**Flood Control Project Maintenance  
Levee Inspections**

## Maintenance Issue Types Only, Levee Inspection Report By Mile - Fall 2024

### Reclamation District No. 0765 Glide

Waterway	Bank	Unit Miles	Inspection Start/End	Inspector
Unit No. 01 Sacramento River	Right	1.72	09/17/2024 09/17/2024	Marvin Marshall

Photo 1 of 1 : FA\_2024\_RD0765\_211\_1\_20240911\_00001.jpg

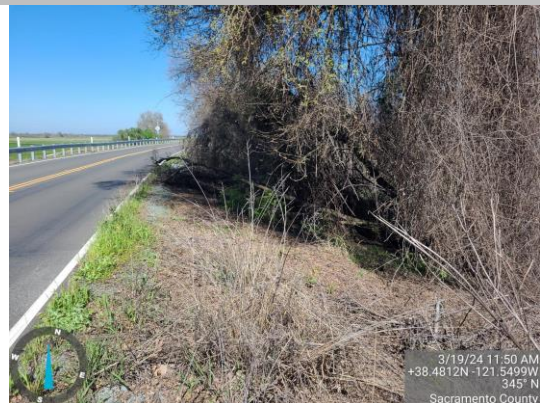
LM Start	1.64	Rating **	M	Issue No.	1
LM End	1.64	Issue Type +	Ma	Location *	WS
Category	Earthen Levee			GPS Latitude/Longitude	
				Start	End
Item	Vegetation			38.481151°	38.481151°
				-121.549866°	-121.549866°
DWR ID	DWR_RD0765_01_s _ 2023_1				
Comment Code					
V2 : Remove the wild growth and woody vegetation other than native grasses from the levee slopes.					
Inspector Comment					
Remove woody vegetation from within 20' of the crown. Trim trees to 5' above grade.
